LEVEL 2 — REV. 15 | THE STAIR IS NOT IN THE CORRIDOR — IT IS A SEPARATE ZONE WEST OF IT

LONG ROAD — RESIDENCE | LEVEL 2 OF 2

SHEET A-20 / LEVEL 2 — IMPERIAL REV. 15 — AUG 2026

1 — LEVEL 2 FLOOR PLAN

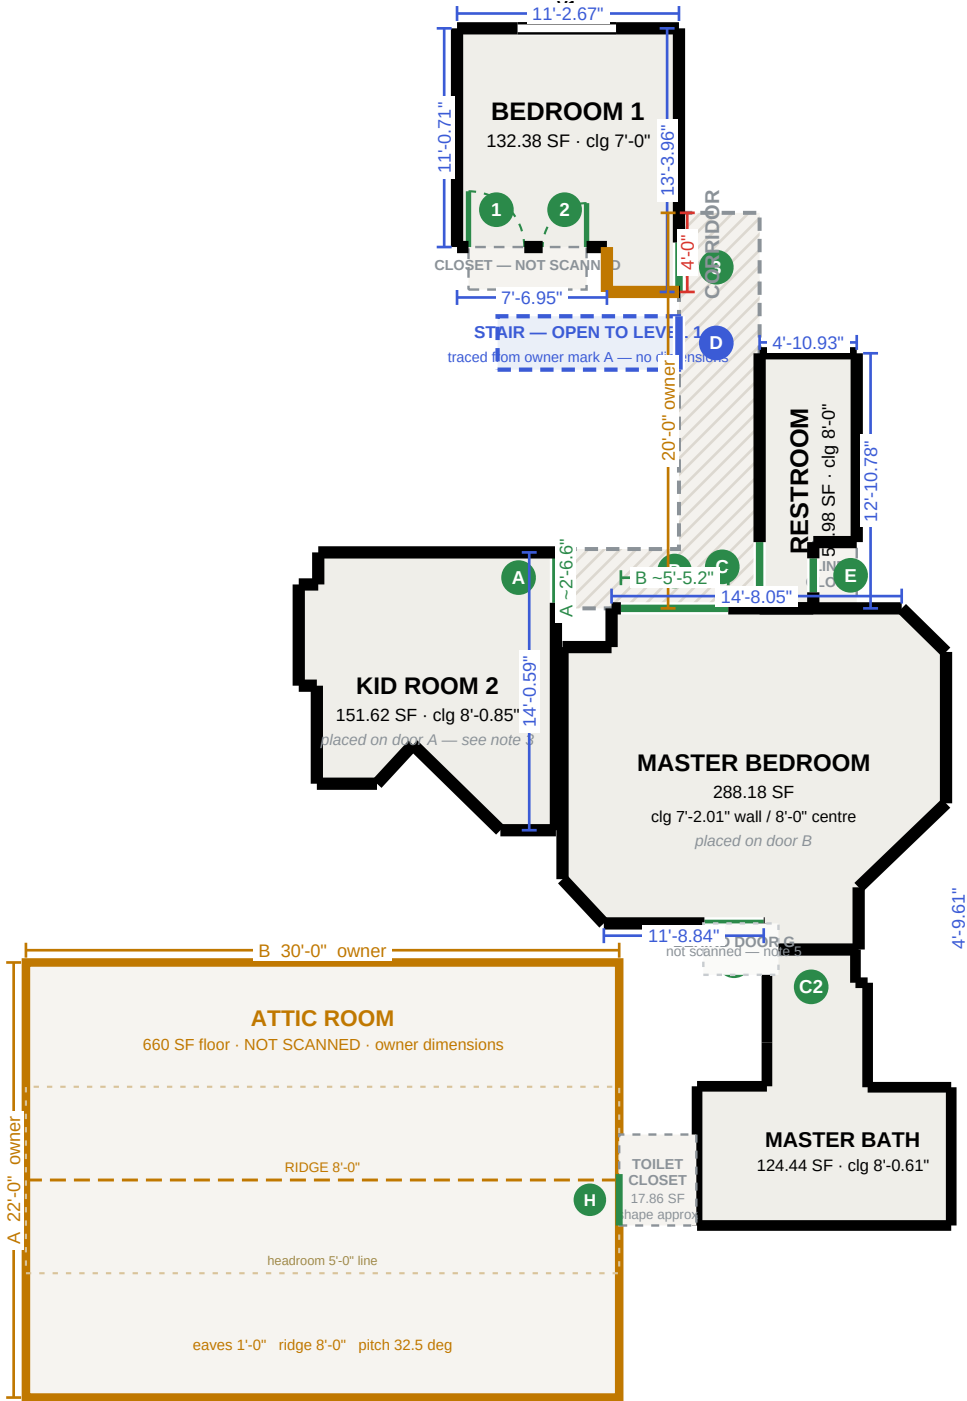
- I HAD THE STAIR IN THE WRONG PLACE, AND THAT WAS THE THING THAT NEVER ADDED UP. You marked A as the stair and B as the corridor. I had been treating the lower sixteen feet of the corridor strip AS the stair. It is not in the corridor at all — it is a separate zone WEST of it, immediately south of bedroom 1, and the corridor is corridor for all twenty feet.

- THIS RETIRES A NOTE I HAVE CARRIED SINCE REV. 6. Every revision since has said that twenty feet of corridor minus four against bedroom 1 left about sixteen feet for a stair, when a flight runs ten to thirteen. The arithmetic was never wrong — my placement was. With the stair moved out, the corridor is a plain 20 ft run and nothing is left over. That note is gone.

- THE STAIR ZONE IS TRACED FROM YOUR MARK, NOT MEASURED. Your two red lines put it at roughly 9'-2" by 2'-8", about 25 SF, drawn dashed in blue with no dimensions. One thing worth saying: 2'-8" is narrow. A flight is normally 3'-0" or wider, and 2'-8" is around the minimum clear width for the flight itself, never mind the floor opening. Either the marks are approximate or this is a genuinely tight stair. One tape measurement across it settles it.

- DOOR D MOVES WITH THE STAIR. It is now an opening in the corridor's west wall over the stair's run, so you step west off the corridor onto the flight. Before it opened onto a zone inside the corridor, which was never right.

THIS RETIRES THE SIXTEEN-FOOT PROBLEM I HAVE FLAGGED SINCE REV. 6. THE CORRIDOR IS CORRIDOR FOR ALL 20 FT; THE STAIR IS ITS OWN ZONE. ALL TWENTY- EIGHT OVERLAP PAIRS ZERO.
